**COMMISSION OF ARCHITECTURAL REVIEW
STAFF REPORT
April 24, 2018, Meeting**

4. **COA-0333405-2018** (C. Romero)

**818 North 25th Street
Union Hill Old and Historic District**

Project Description: Construct a shed and a pergola in the rear yard.

Rear of 818 North 25th Street (April 2018)

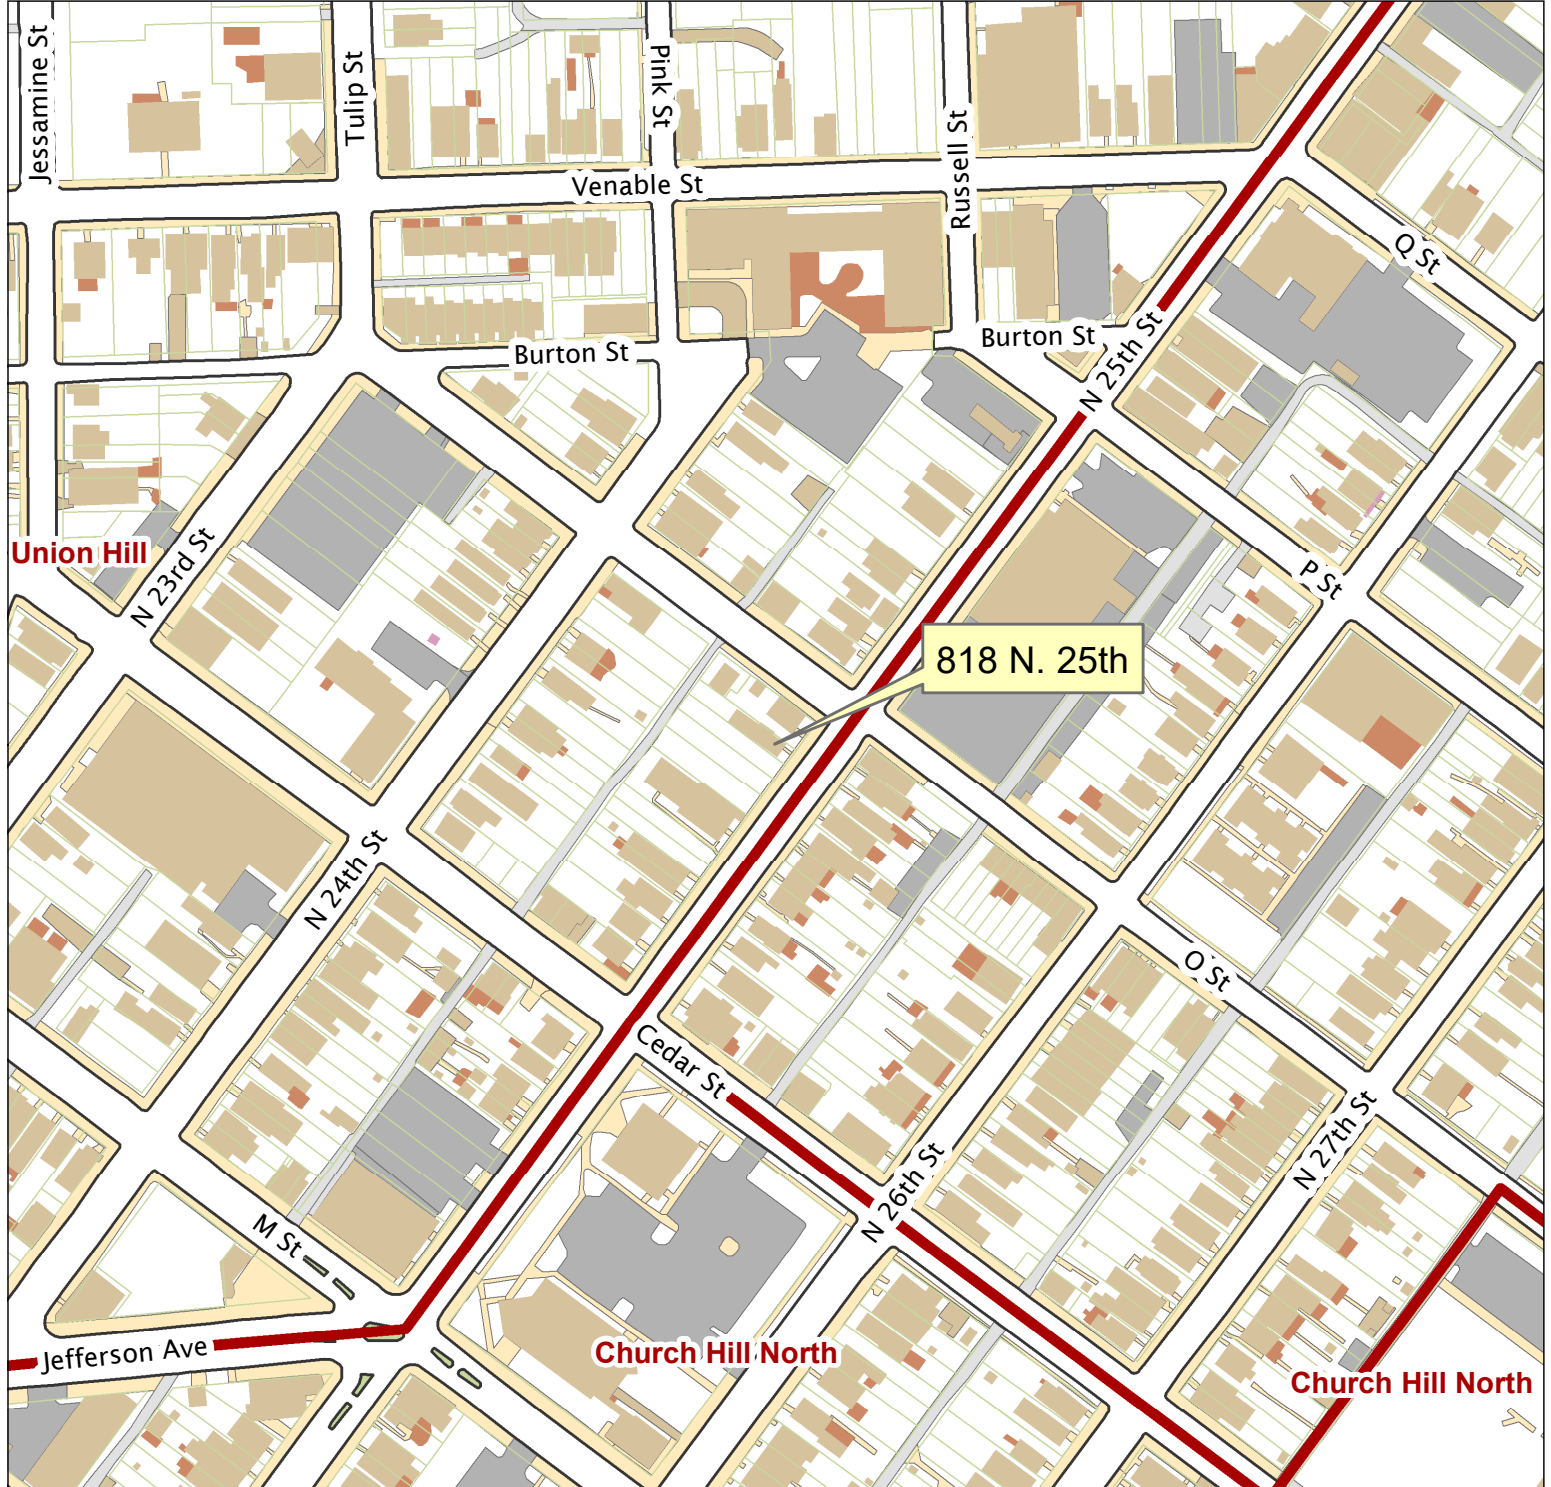
Pergola: The *Richmond Old and Historic Districts Handbook and Design Review Guidelines* offer very little guidance about small, freestanding structures such as arbors and pergolas. It does, however, note that auxiliary structures should be compatible with the design of the major buildings on the site, and respect the siting and massing of existing auxiliary structures in the district (pg. 51, Residential Outbuildings 1-4). Staff has concerns that the scale and location of the pergola is not consistent with pergolas found in the district. Pergolas found in the district are typically smaller in scale and sited within rear yards. The proposed pergola is located over the parking area and will function as a carport which is not a building form found in the District. Additionally, the proposed pergola is larger than the typical small garden structures found in the district. Staff recommends denial of the proposed pergola as its size and siting do not respect the pattern found in the district for pergolas.

Shed: The Guidelines note that outbuildings should be compatible with the primary building on site, small in scale, located in the rear yard, and compatible with other outbuildings in the District (pg. 51, Residential Outbuildings 1-4). The small shed is located in the rear yard and will be minimally visible from the public right of way. The proposed fiber cement siding is compatible with the siding on the primary structure. Staff recommends approval of the proposed shed with the following conditions: the siding be smooth and without a bead and paint colors be submitted to staff for administrative review and approval.

Staff recommends partial approval of the project with conditions.
